Rule Change: Generator Technical Performance Standards [ERC0222]

General Electric (GE) is pleased to provide our response to the Consultation paper – National Electricity Amendment (Generator Technical Performance Standards) Rule 2017, **[ERC0222]**.

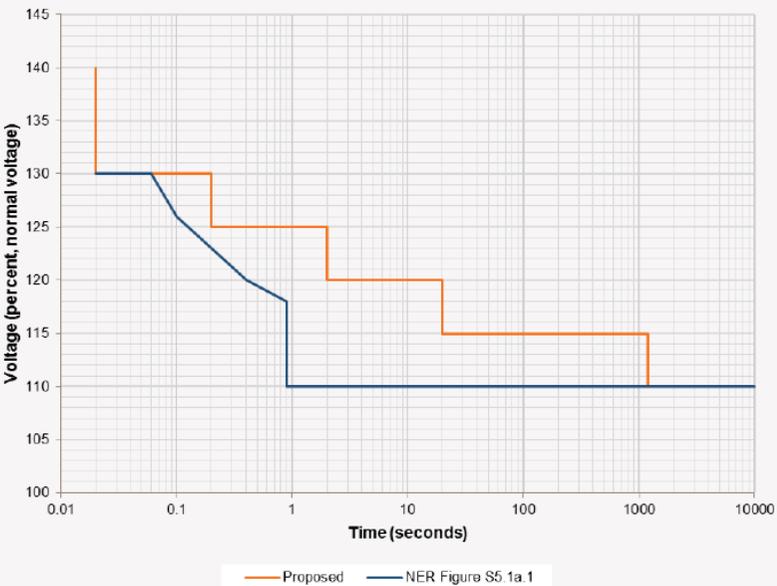
Response to item 14 & 15	<p>In general, we agree that generating units need to be resilient against repetitive disturbances however this proposed change appears to create a misalignment between reality and idealised power system operation. The events of 28 September 2016 in South Australia were extreme and pushed the power system to its limits. Therefore, creating standards based on this one isolated event may not be an efficient approach to the design of the NEM for the longer term. For such extreme events, there must be back up special protection schemes/systems in place to preserve the system from collapse, and such designs should take the capability of the power system components into account. Whilst some generators can meet the proposed requirements, this is not a uniform capability. Generators require significant testing in order to demonstrate this capability and there are no ancillary plant options available to increase the capability of a generator to meet this requirement. For example type 3 and type 4 wind turbines will be unlikely to meet this and would require significant redesign to withstand the thermal and mechanical stresses. It would be prudent for AEMO to develop a more realistic requirement considering the probability of different fault types allowing a more realistic design of generation technology without driving an LCOE increase. The fault types to ride through has a direct bearing on design of the generating systems. The proposed rule change and supporting documentation does not distinguish regarding the detailed faults and voltage dips in the different phases. The drafted access standard would need to be read in a way that a sequence of 15 three phase faults within 5 minutes at or close to a generating system’s connection point with each fault cleared within say 120ms would need to be withstand. GE is not convinced this is a realistic scenario and the latest system disturbance analysis supports AEMO’s conclusion.</p> <p>Without a boundary limit on the actual low voltage ride through requirements, ie. voltage profile vs time, it will not be possible to ascertain the actual requirements on say a typical synchronous machine shaftline, and to identify whether redesign of the synchronous machine shaftline is required.</p>

- Power system performance during an event that creates multiple LVRT events is highly unpredictable and could lead to say N-3 or higher network configurations. This requirement could literally mean the assets in the network are tripping off all around the generator to ensure they are protected and that the community is protected, but that generators would keep operating irrespective of potential damage;
- The potential implications this requirement has on the drive train oscillations with type 3 and type 4 wind turbines; and
- Narrow the technology providers for generators in the NEM.

As previously set out the NEO expects efficient investment and this requires performance to be assessed against the characteristics of the connection point. Onerous and uniform technical requirements introduce unnecessary costs and capabilities. AEMO and the NSPs have all the knowledge and should guide generator proponents to select any plant/technology required to meet the level of performance expected at the respective location.

GE is concerned that this requirement will be a barrier to entry for many generator technologies. AEMO should propose reasonable technical requirements.
